Work Order ID 88693

Item Name: 205 Skidtube bent detail

DRAWING NO. D2580	TITLE 205 SKIDTUBE ASSEMBLY	REV. E	DART AEROSPACE LTD ENGINEERING ORDER	D.E.O. NO. D2580-E-1	SHEET NO. SHEET 1 OF 1	SCALE NTS
DRAWN <i>UP</i>	CHECKED <i>ASS</i>	MFG. APPR. <i>EC</i>	APPROVED <i>[Signature]</i>	DE APPR. <i>[Signature]</i>		
DATE 11.12.13	DATE 11.12.13	DATE 11.12.13	DATE 11.12.13	DATE 11.12.13

CHANGE ALL C'BORED WELDED CROSSBOLT SPACERS TO SWAGED SPACERS

SECTION B-B
D5-2
SCALE 5X

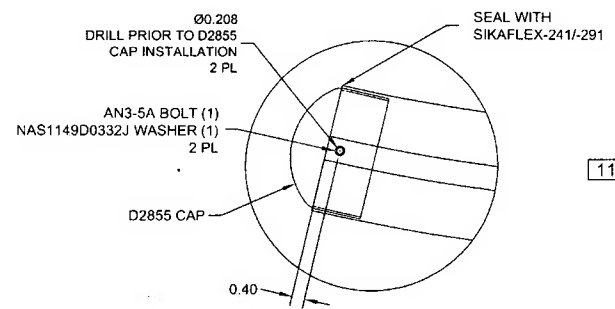
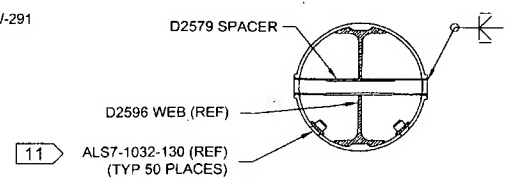
- AFTER DRILLING AND BENDING ASSEMBLY
PERFORM THE FOLLOWING FOR Ø0.508 HOLES ONLY:
1. CHAMFER HOLE 0.050 X 45°
 2. INSERT D2579 SPACER (20 PLACES)
 3. WELD INTO PLACE AND GRIND FLUSH
 4. C'BORE D2579 SPACER TO Ø0.437 X 1.00 DEEP

1. INSERT D4202-1 SPACER, 20 PL (-041) OR 20 PL (-045) OR 25 PL (-047)
2. SWAGE TO Ø0.437 X 1.00 DEEP PER QSI 002
3. TRIM / GRIND FLUSH PER QSI 002

SECTION F-F
SCALE 5X

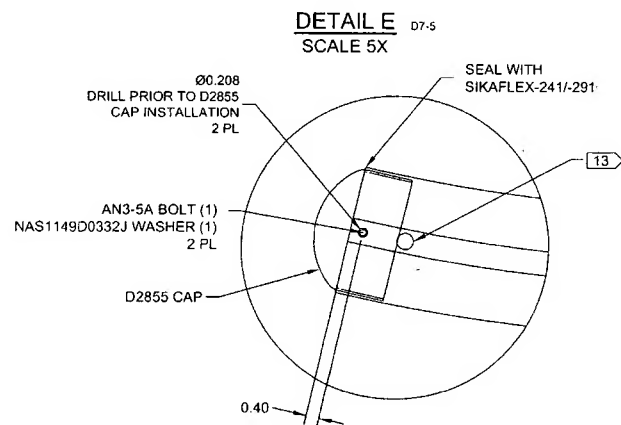
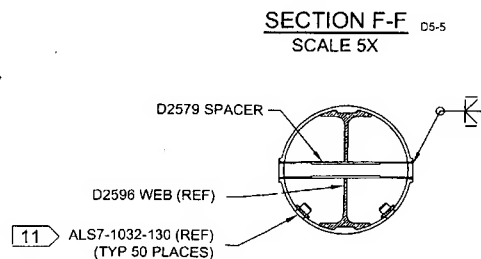
- AFTER DRILLING AND BENDING ASSEMBLY
PERFORM THE FOLLOWING FOR Ø0.508 HOLES ONLY:
1. CHAMFER HOLE 0.050 X 45°
 2. INSERT D2579 SPACER (24 PLACES)
 3. WELD INTO PLACE AND GRIND FLUSH
 4. C'BORE D2579 SPACER TO Ø0.437 X 1.00 DEEP

WELD 4X D2579 SPACERS PER DWG
IN LOCATIONS MARKED "NO C'BORE".
REF SHEET 4 OF DWG.

SECTION I-I D5-7
SCALE 5X

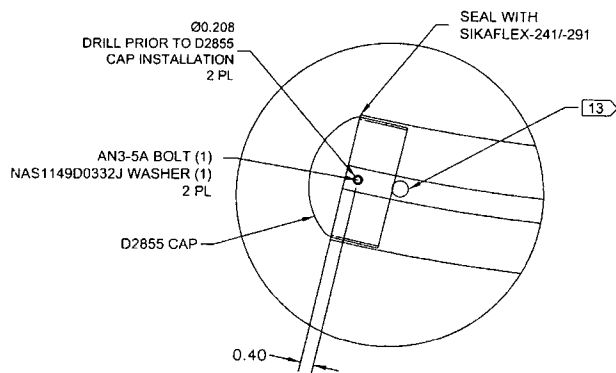
AFTER DRILLING AND BENDING ASSEMBLY
PERFORM THE FOLLOWING FOR Ø0.508 HOLES ONLY:
1 CHAMFER HOLE 0.050 X 45°
2 INSERT D2579 SPACER (25 PLACES)
3 WELD INTO PLACE AND GRIND FLUSH
4 C-BORE D2579 SPACER TO Ø0.437 X 1.00 DEEP

SECTION B-B, SECTION F-F, & SECTION I-I ARE AMENDED AS FOLLOWS
FOR ALL HOLES THAT WERE ORIGINALLY C'BORED:

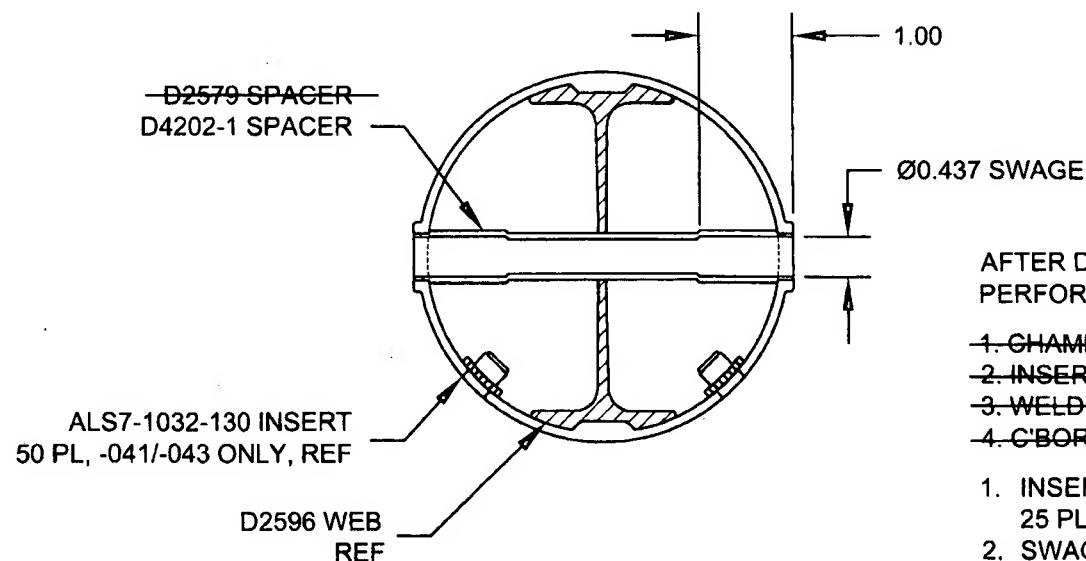
PARTS LIST IS AMENDED AS FOLLOWS:

WAS

QTY	QTY	QTY	PART NUMBER	DESCRIPTION
-041	-045	-047		
20	24	25	D2579	CROSS BOLT SPACER

IS

4		* D2579	CROSS BOLT SPACER
20	20	25	D4202-1	SPACER

*** FOR -045 SKIDTUBE ONLY:**

- ~~1. CHAMFER HOLE 0.060 X 45°~~
- ~~2. INSERT D2579 SPACER (20 PLACES)~~
- ~~3. WELD INTO PLACE AND GRIND FLUSH~~
- ~~4. C'BORE D2579 SPACER TO Ø0.437 X 1.00 DEEP~~

SECTION B-B, F-F, I-I
NOT TO SCALE
